PRODUCT CHANGE NOTICE

PCN#18-129NOTIFICATION DATE: **October 25, 2018****MODEL(S) AFFECTED:**

Change of pin header subassembly

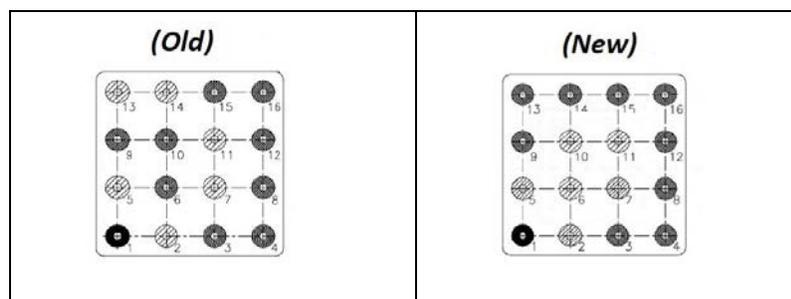
Glass beads added to pins 13 & 14 and removed from pins 6 & 10.
No change to FIT or FUNCTION, specification remains unchanged.
